Denton Homes Limited

9th July 2025

DM/23/2794 – Variation of Conditions 19 & 20 at Gatehouse Farm, Gatehouse Lane, Hassocks

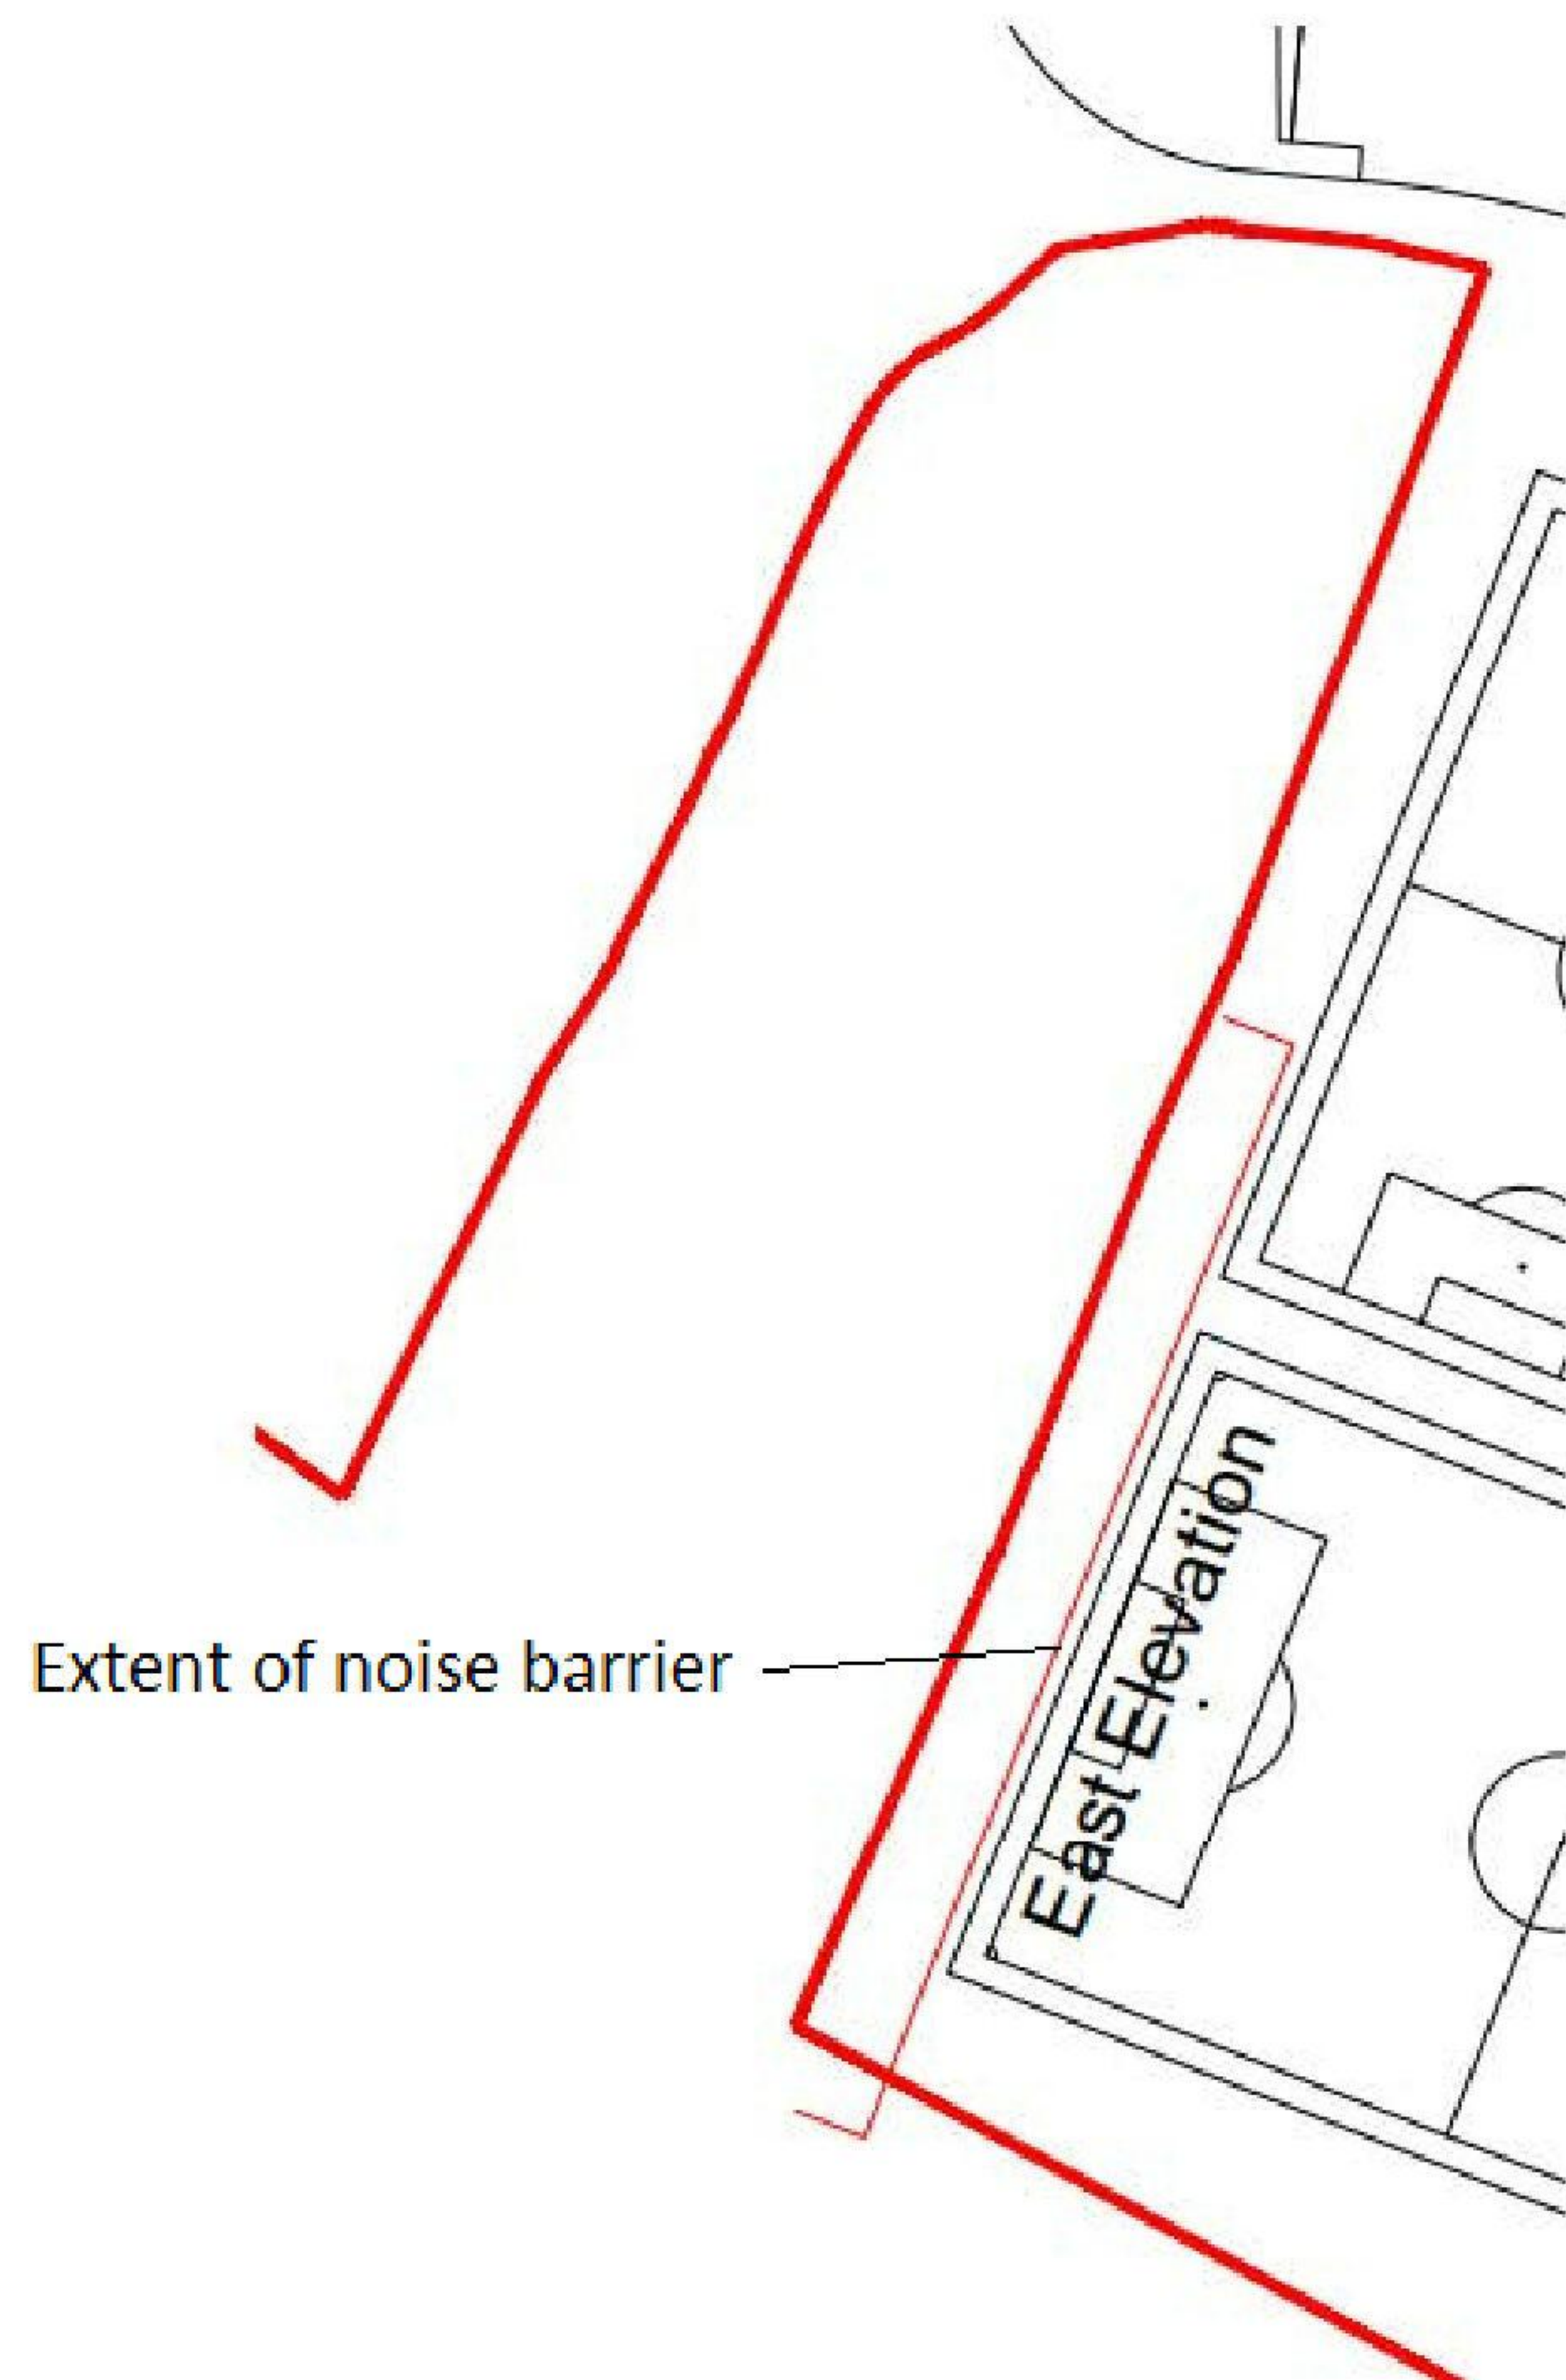
The approved scheme shows how an acoustic fence would be added to the eastern boundary and part of the northern boundary at a height of 2.5m. The extent of the acoustic fencing is shown below in purple:

The current application proposes that the acoustic fence on the eastern boundary of the Gatehouse Farm Site be removed where it is directly behind an identical acoustic barrier within the Centre for Outdoor Sports.

A more conventional close boarded fence of some 1.8m in height would be installed on the boundary as an alternative to the approved acoustic fence.

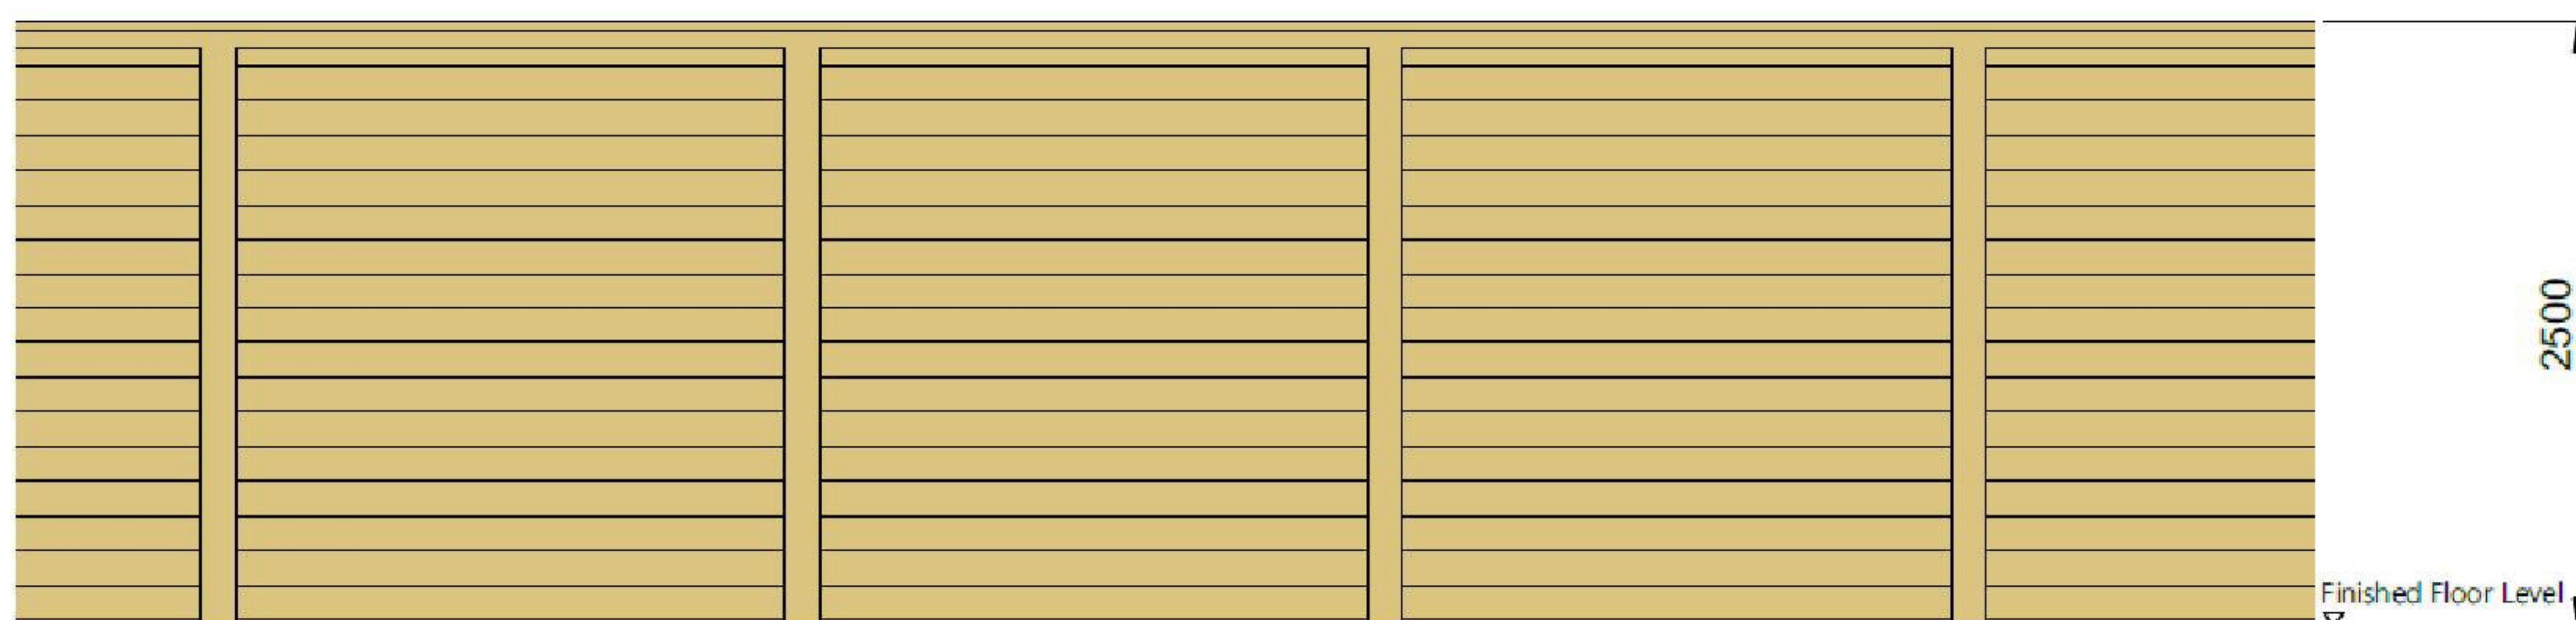
At the same time, a noise barrier of the same height and specification would be inset around 1m from the eastern boundary within the adjoining "Centre for Outdoor Sports" development. It would extend for circa 96m, with the extent of the noise barrier in that case indicated in red below:
